REMARKS

Claims 1-33 are pending in the application. In the Office action of February 24, 2005, claims 1-33 were made subject to a restriction requirement. In addition, many of the drawings were objected to.

FIG. 3

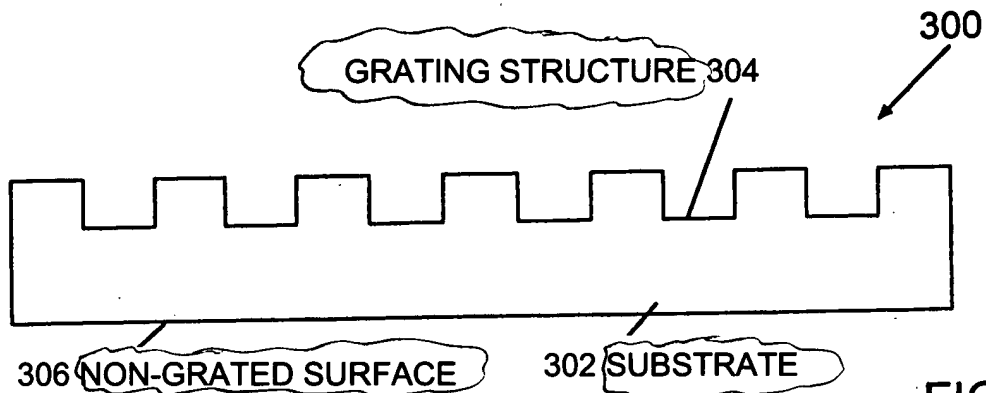
FIG. 3 was further objected to on the grounds that reference numbers 302 and 306 are duplicate reference numbers for the same item. The objection should be withdrawn inasmuch as 302 refers to a substrate, and 306 refers to a non-grated surface of the substrate 302.

- The second sheet which contains FIGS. 3-5 replaces the original sheet that contains FIGS. 3-5. FIGS. 3-5 have been changed as required by the examiner.

FIG. 23

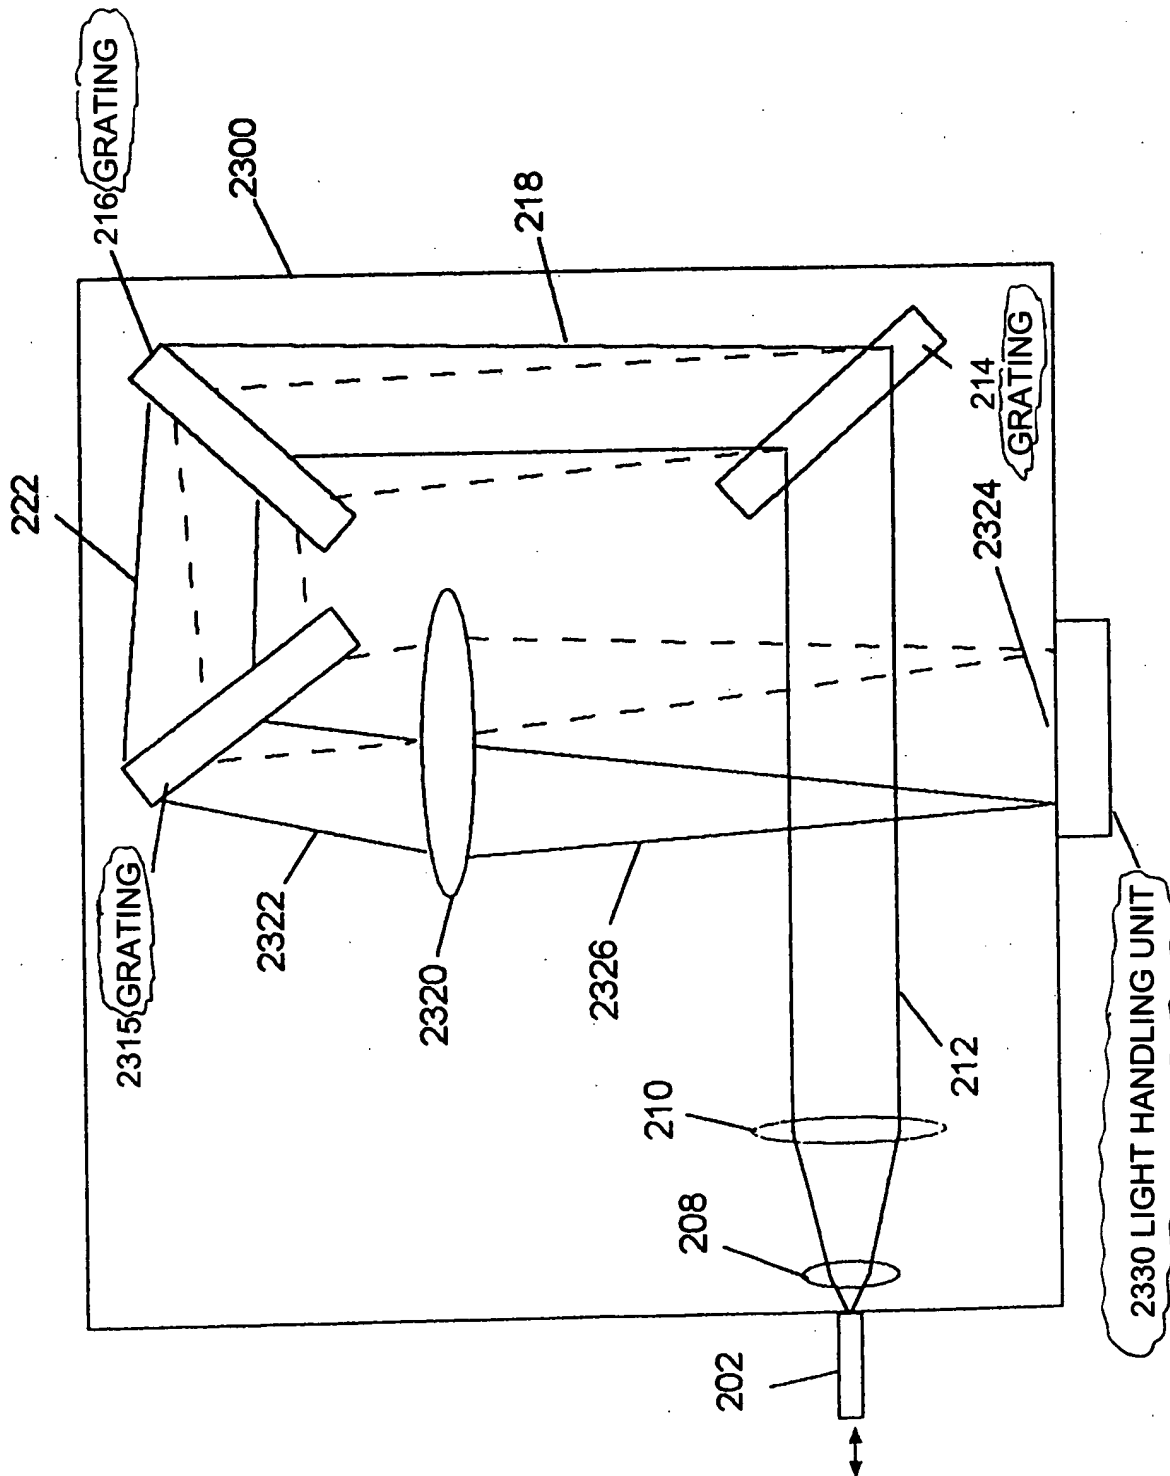
- The eighth sheet which contains FIG. 23 replaces the prior replacement sheet that contains FIG. 23. FIG. 23 has been changed as required by the examiner. In addition, the label for reference number 2330 has been repositioned.

FIG. 24

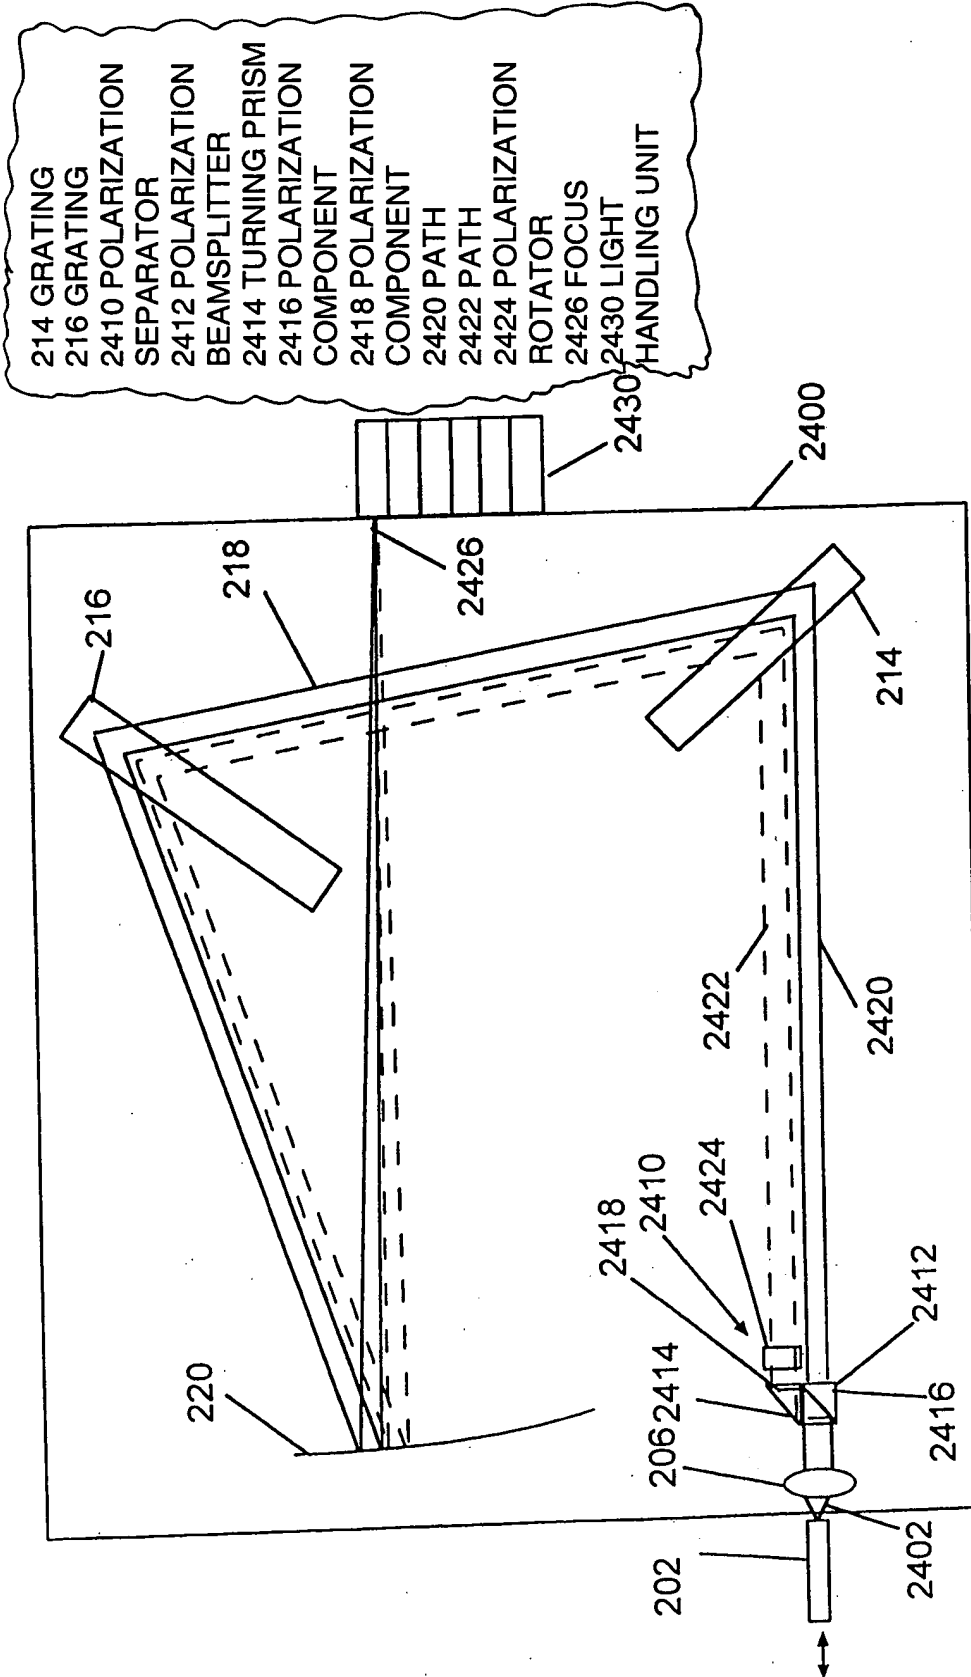
FIG. 24 was further objected to on the grounds that (a) reference numbers 2414 and 2418 are duplicate reference numbers for the same item; and (b) reference numbers 2416 and 2412 are duplicate reference numbers for the same item. The objection as to "(a)" should be withdrawn inasmuch as 2414 refers to a turning prism, and 2418 refers to a polarization component of a beam transmitted through the prism 2414. The objection as to "(b)" should be withdrawn inasmuch as 2412 refers to a polarization beamsplitter, and 2416 refers to a polarization component of a beam transmitted through the beamsplitter 2412.

- The ninth sheet which contains FIG. 24 replaces the prior replacement sheet that contains FIG. 24. FIG. 24 has been changed as required by the examiner. In addition, a few additional labels have been included to further improve understanding of the drawing.

FIG. 25B

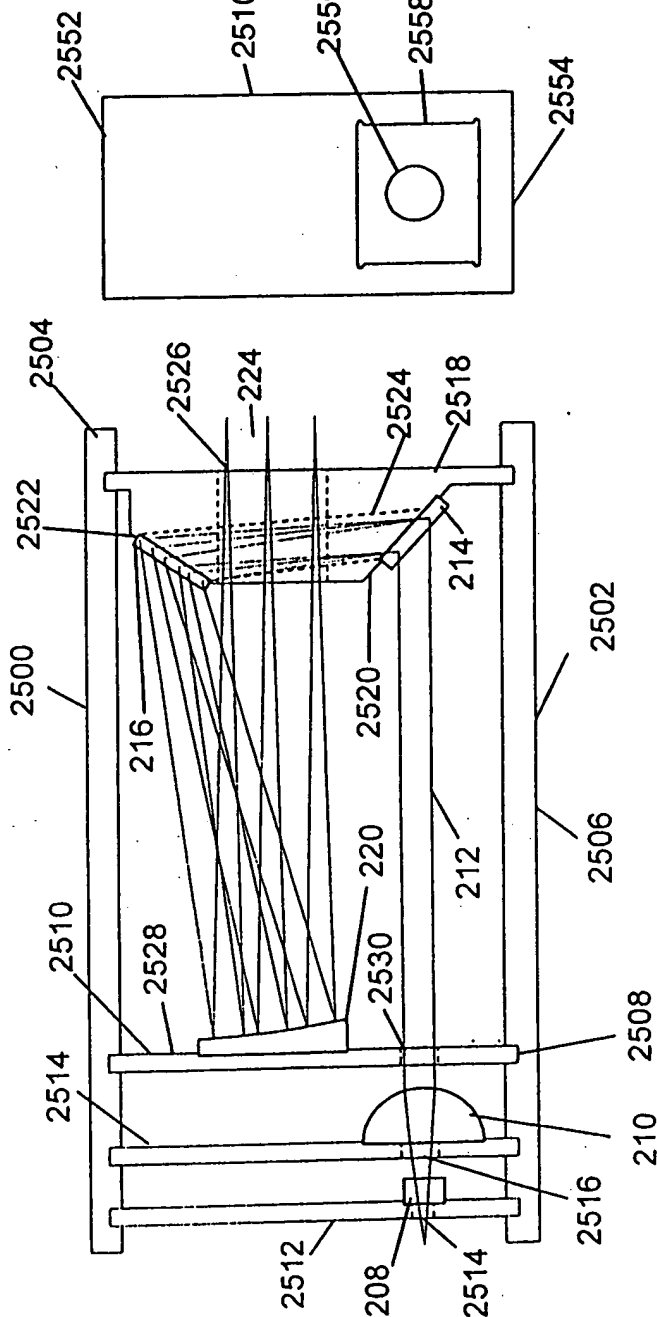
FIGS. 25A and 25B were further objected to on the grounds that (a) reference numbers 2506 and 2502 are duplicate reference numbers for the same item; (b) reference numbers 2510, 2528 and 2508 are duplicate reference numbers for the same item; and (c) reference numbers 2552, 2510 and 2554 are duplicate reference numbers for the same item. The objection as to "(a)" should be withdrawn inasmuch as 2502 refers to a frame, and 2506 refers to a lower rail of the frame 2502. The objection as to "(b)" should be withdrawn inasmuch as 2508 refers to multiple slots, 2510 refers to multiple mounting plates that may be fitted into the slots 2508, and 2528 refers to a particular one of the plates 2510. The objection as to "(c)" should be withdrawn inasmuch as 2510 is a generic representation of the multiple mounting plates, and 2552 and 2554 refer to upper and lower edges of the generic representation.

- The tenth sheet which contains FIGS. 25A and 25B replaces the original sheet that contains FIGS. 25A and 25B. FIGS. 25A and 25B have been changed as required by the examiner. In addition, a few additional labels have been included to further improve understanding of the drawing.

FIG. 28

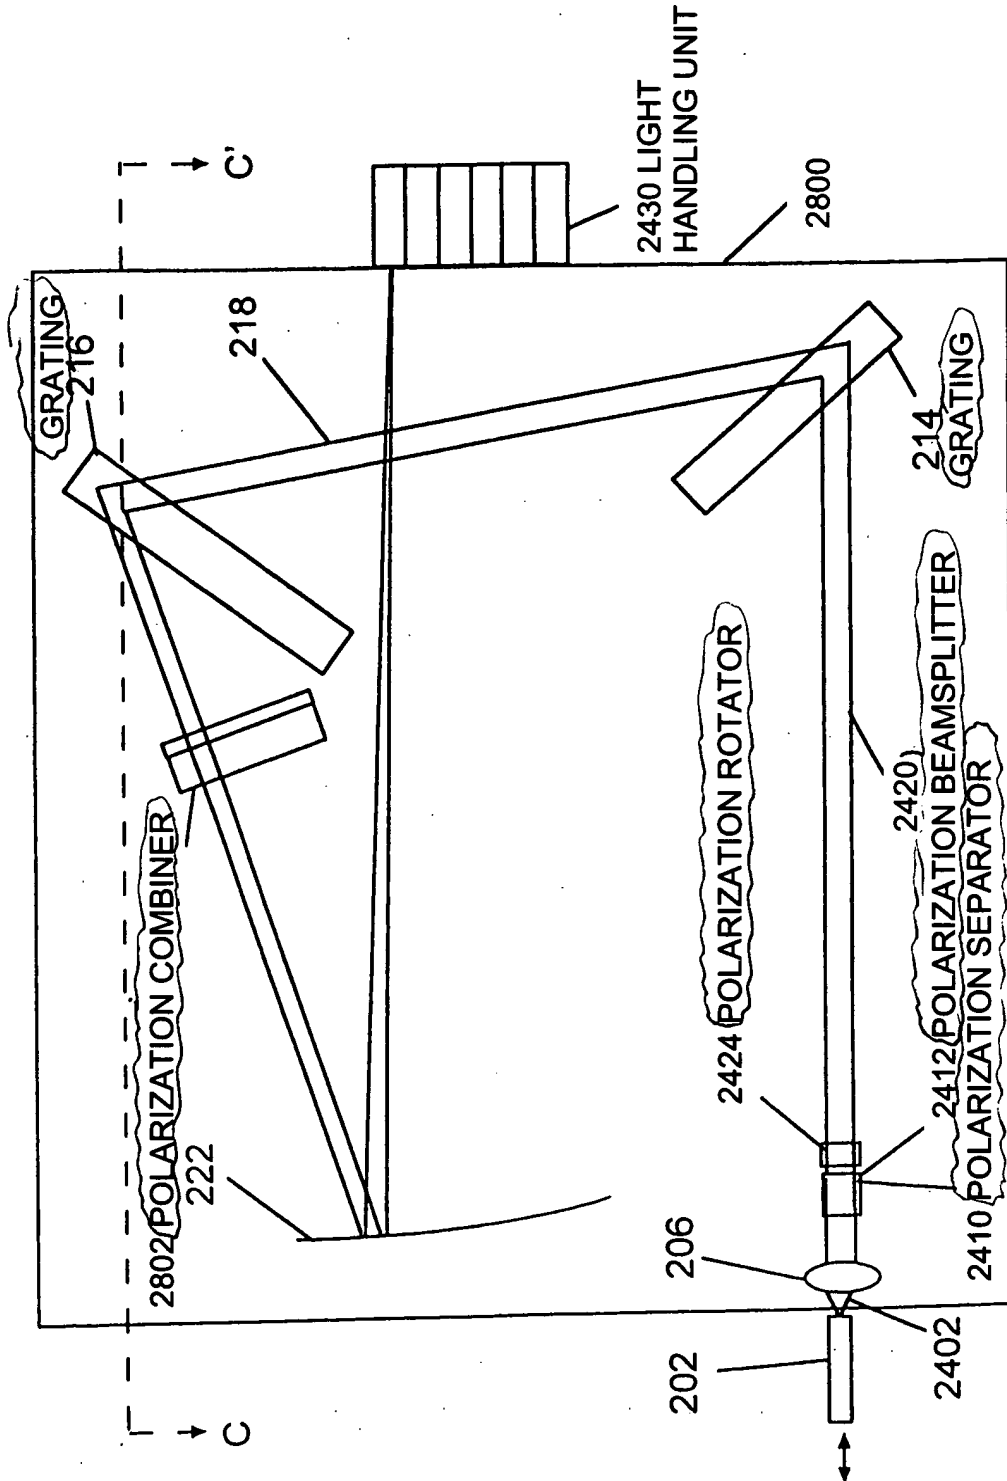
FIG. 28 was further objected to on the grounds that reference numbers 2410 and 2412 are duplicate reference numbers for the same item. The objection should be withdrawn inasmuch as 2410 refers to a polarization separator, and 2412 refers to a polarization beamsplitter which is part of the polarization separator 2410.

- The eleventh sheet which contains FIG. 28 replaces the prior replacement sheet that contains FIG. 28. FIG. 28 has been changed as required by the examiner.
